STATE OF HAWAII
DEPARTMENT OF TRANSPORTATION
HIGHWAYS DIVISION
HONOLULU, HAWAII
"AS-BUILT"
PLANS FOR
OLD KEA'AU-PAHOA ROAD RESURFACING
KEA'AU TO KEAAU HIGH SCHOOL
PROJECT NO. 139A-01-05M
DISTRICT OF PUNA
ISLAND OF HAWAII

CHANGES MADE DURING CONSTRUCTION HAVE BEEN INCORPORATED ON THESE PLANS EXCEPT CHANGES IN THE ORIGINAL THEORETICAL QUANTITIES. FOR ACTUAL QUANTITIES, REFER TO PROJECT LEDGER AND/OR COMPUTATION BOOK.

SIDEWALK CULVERT PLAN - TYPE 2
Scale: 1/2" = 1'-0"

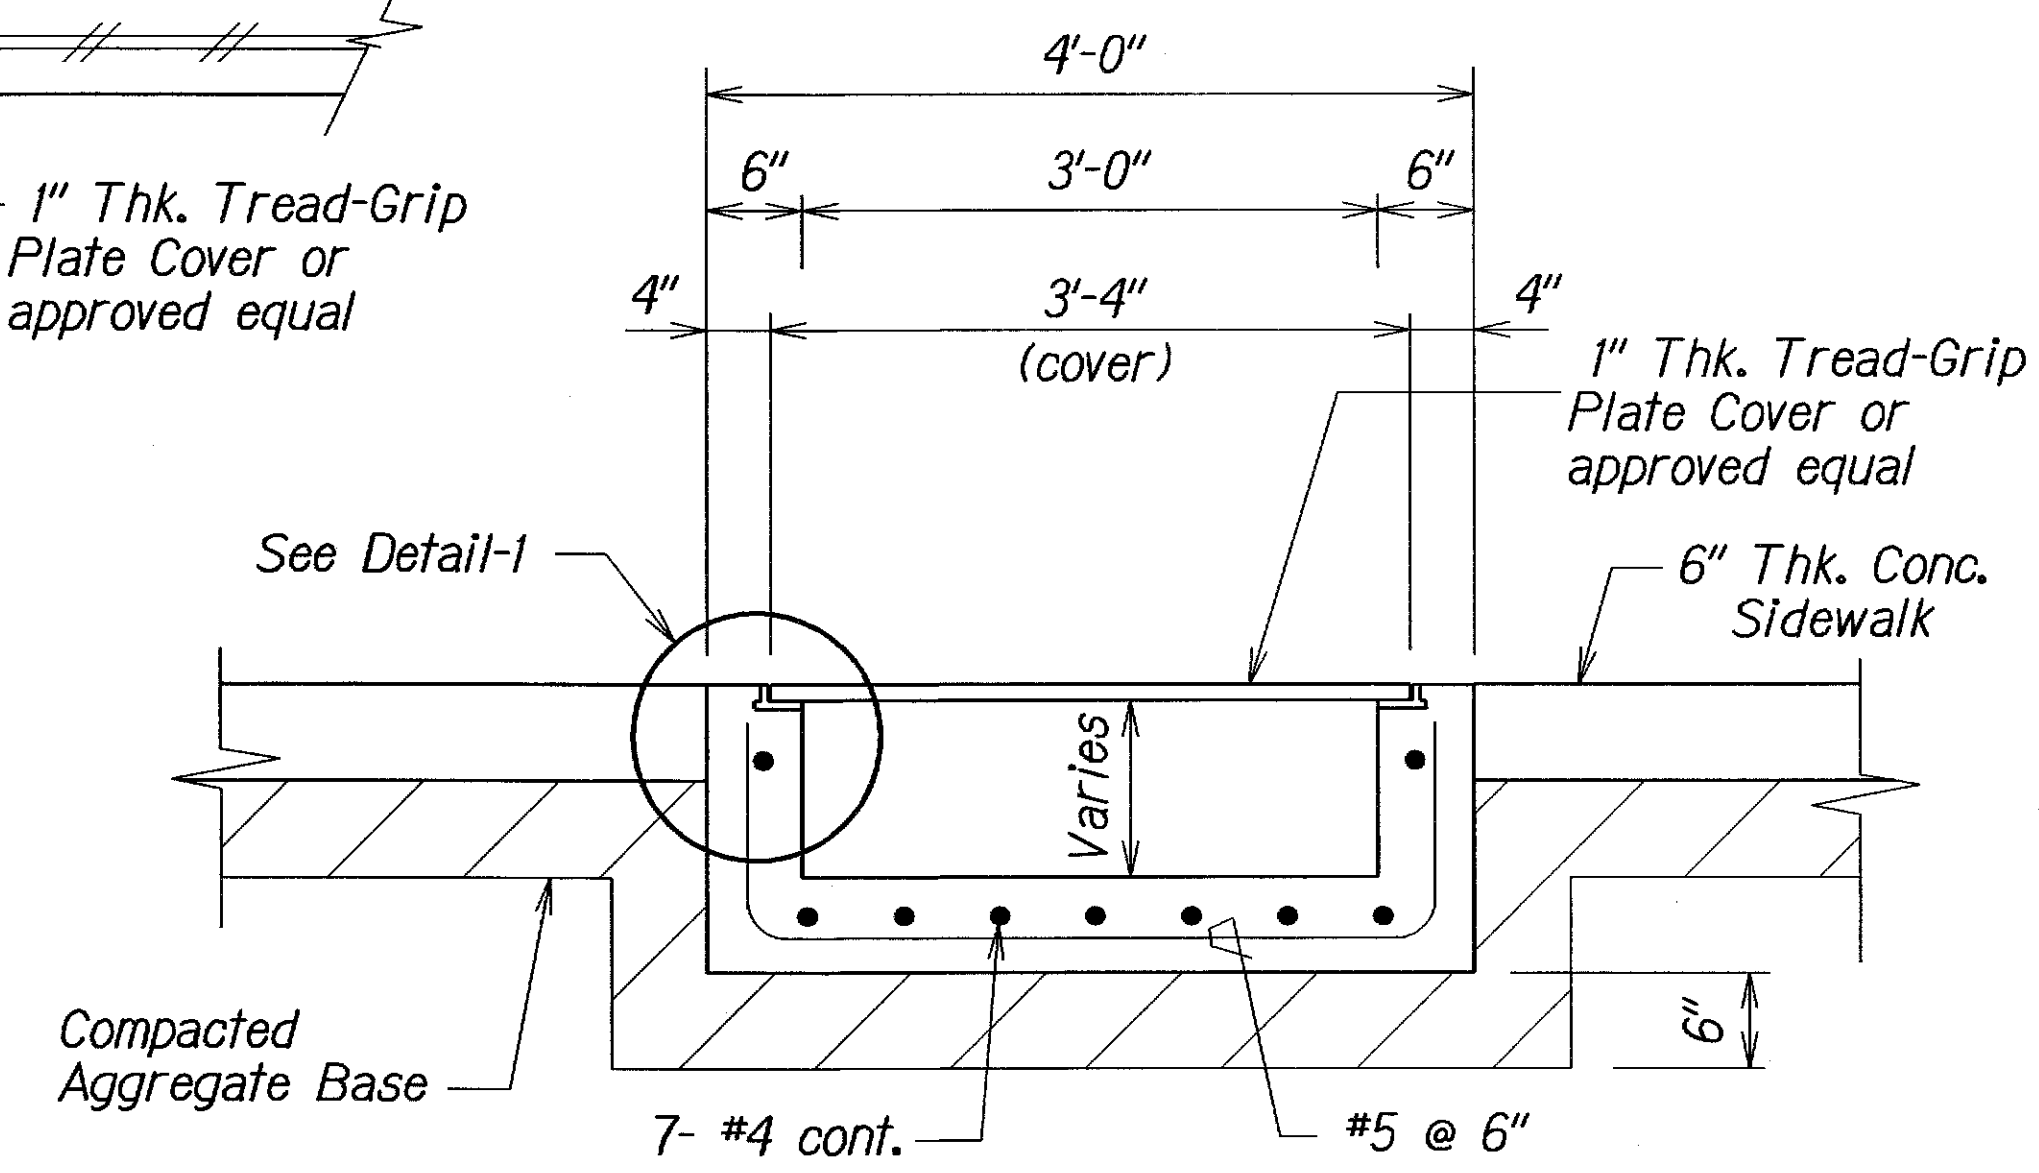
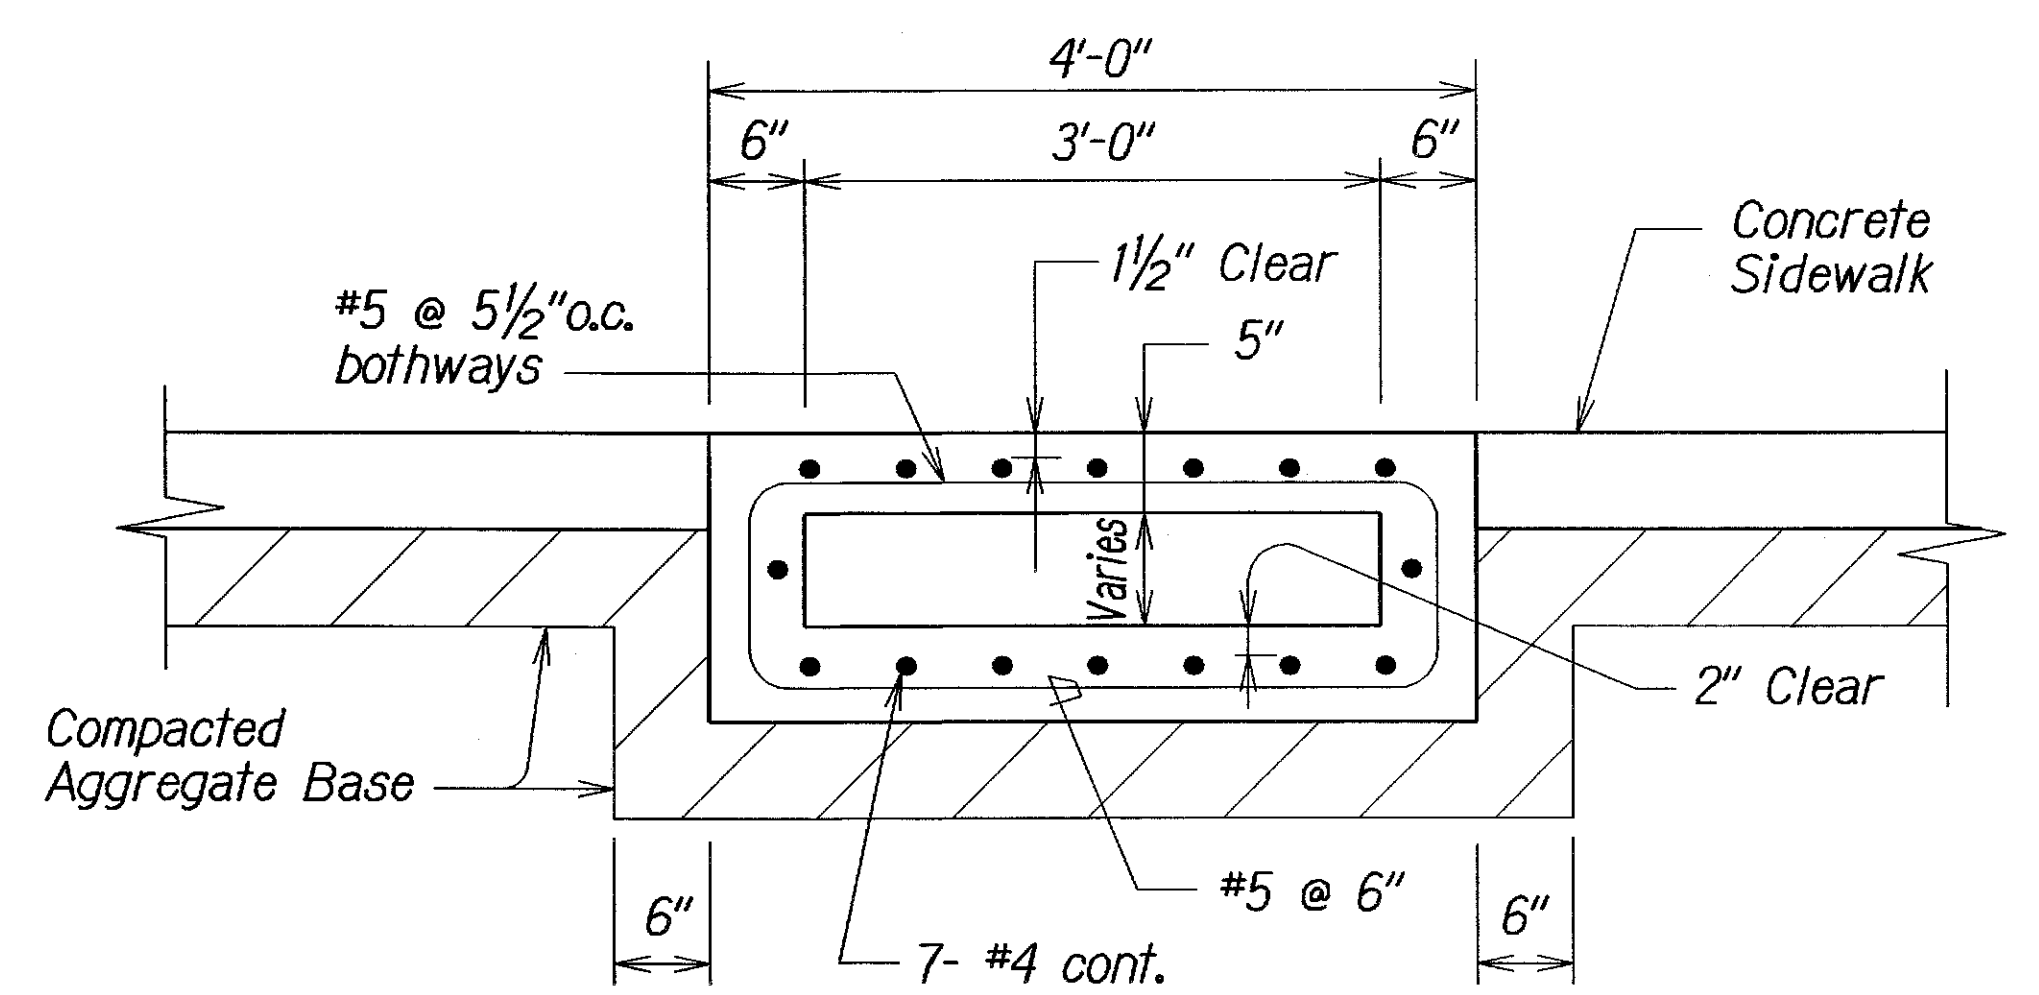
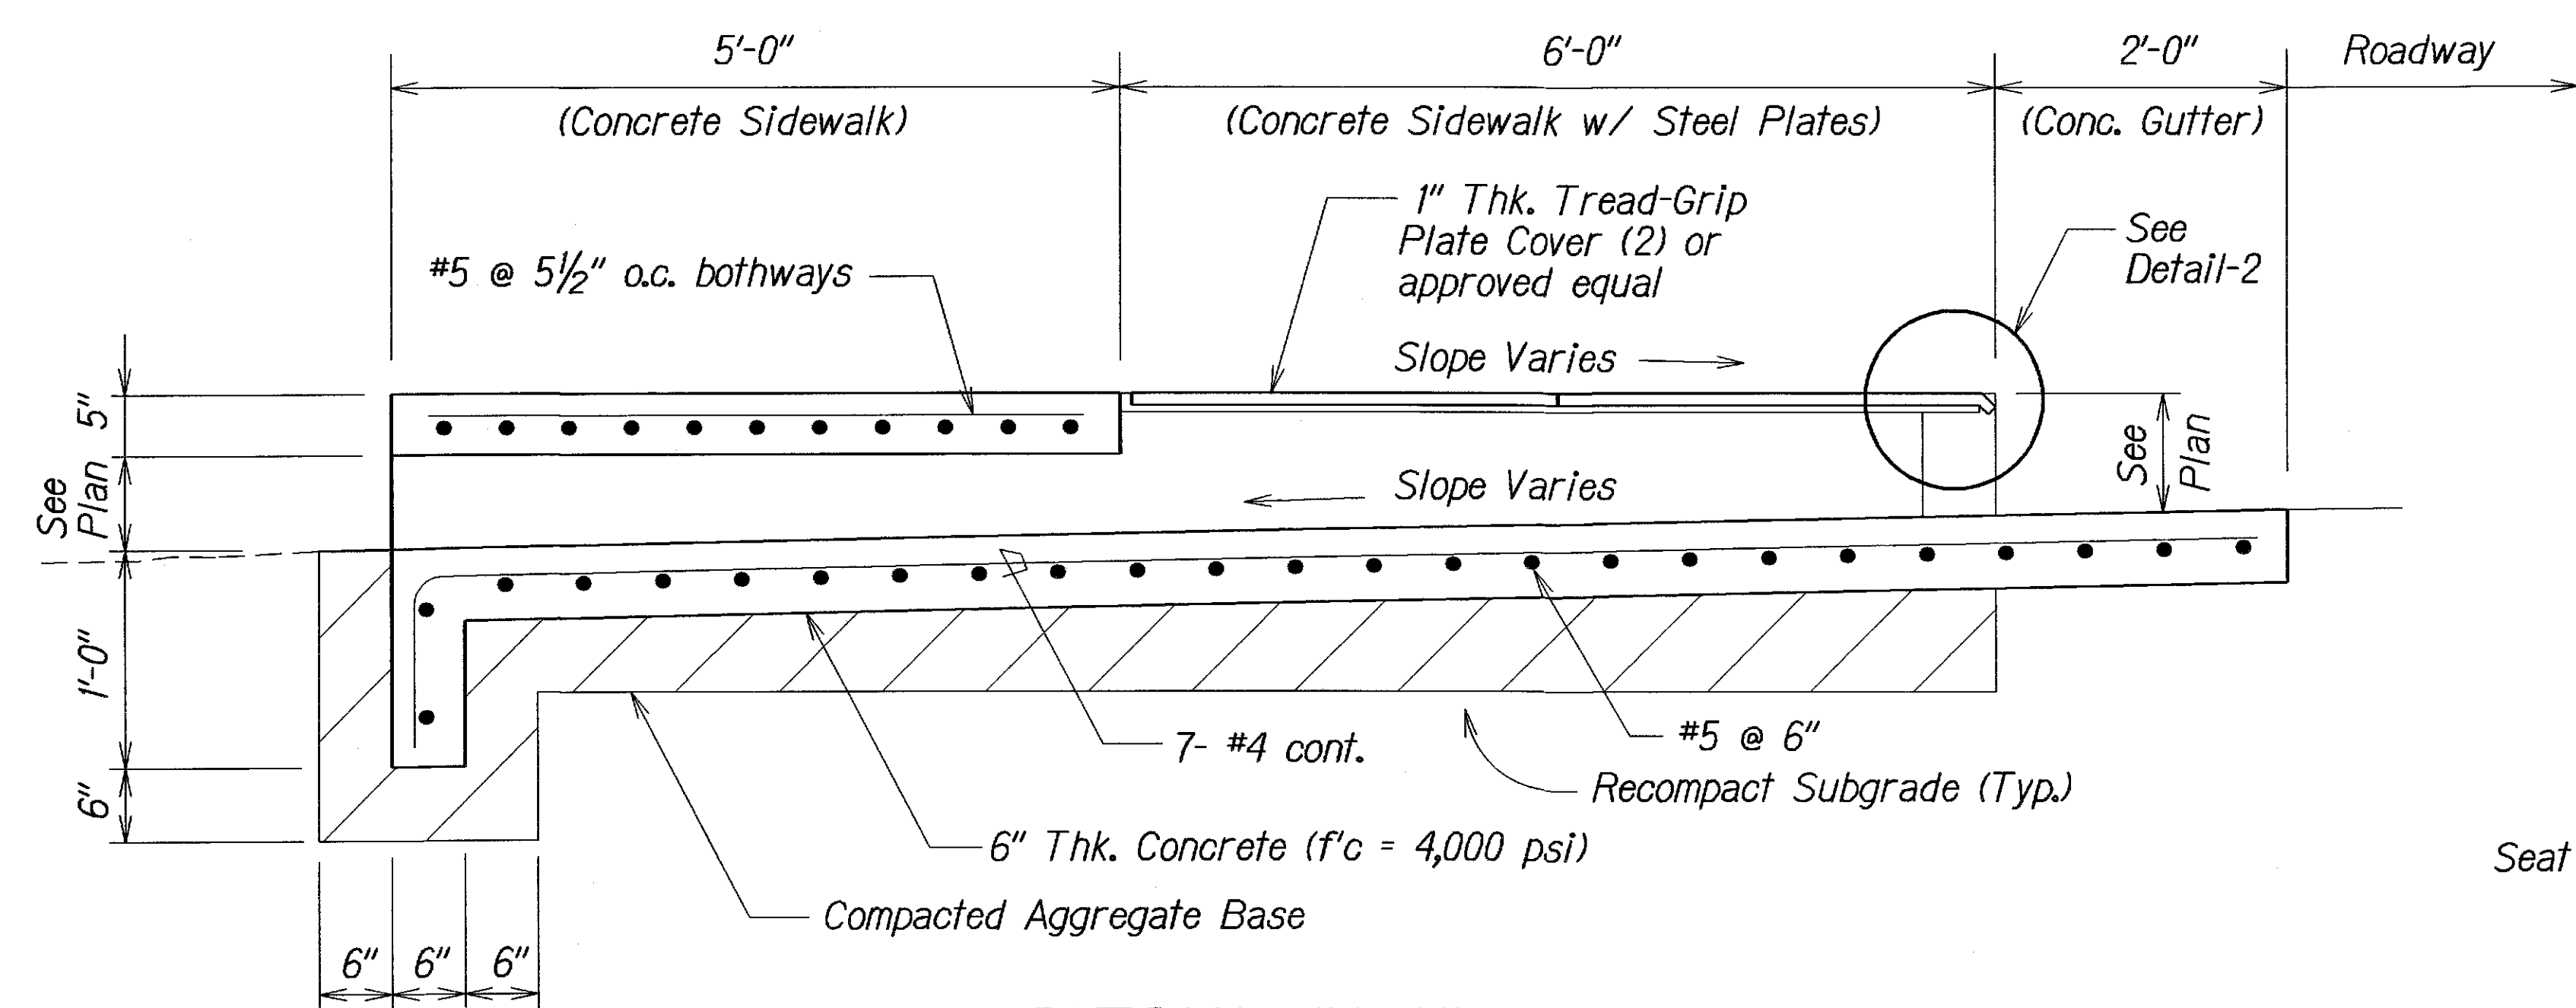
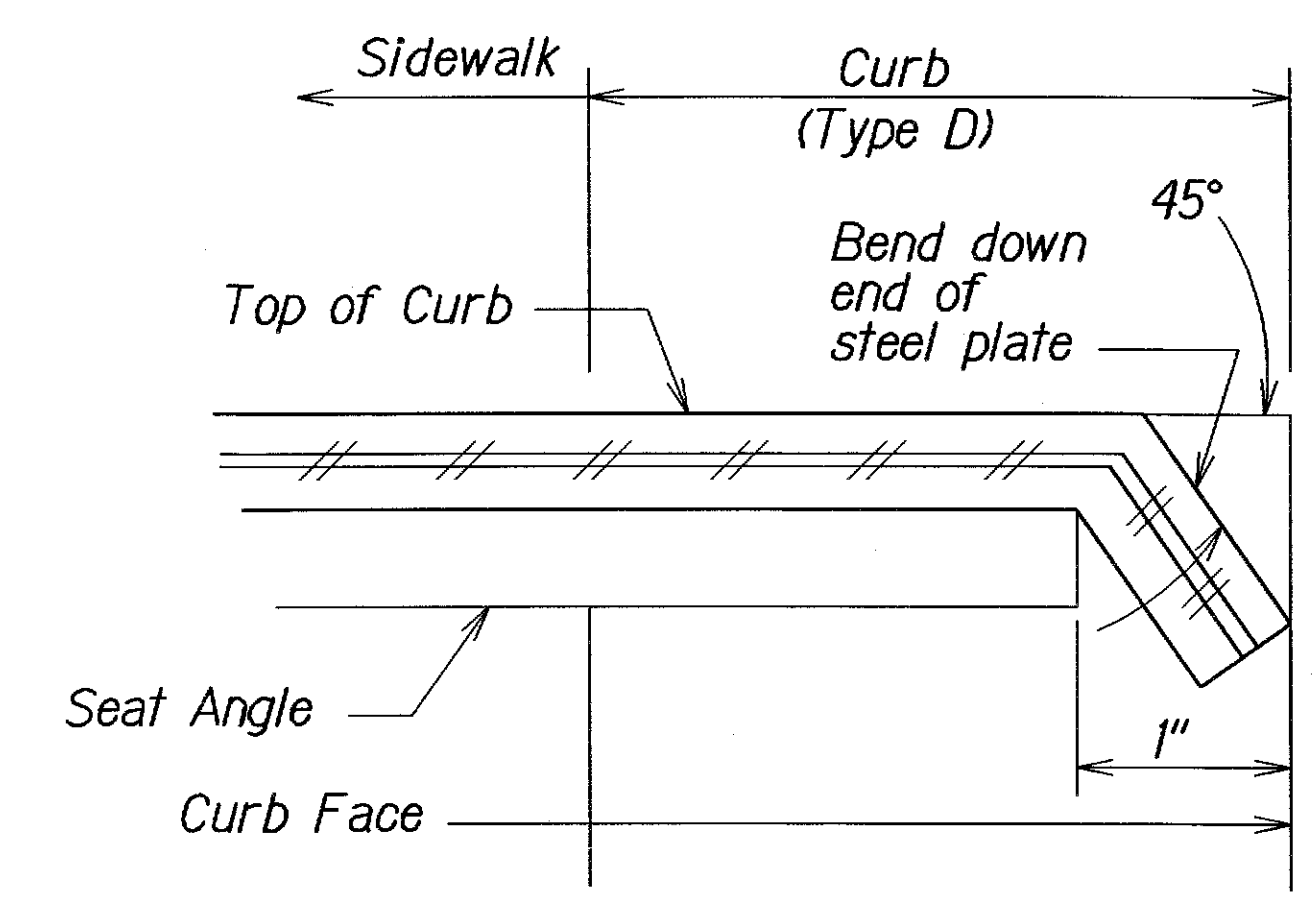
6/07/07	Revise culvert details and notes, per Addendum No. 1.
DATE	REVISION
STATE OF HAWAII DEPARTMENT OF TRANSPORTATION HIGHWAYS DIVISION TYPICAL SIDEWALK CULVERT DETAILS OLD KEA'AU-PAHOA ROAD RESURFACING KEA'AU TO KEAAU HIGH SCHOOL PROJECT NO. 139A-01-05M Scale: As Shown Date: Nov., 2004 SHEET No. 6 OF 7 SHEETS
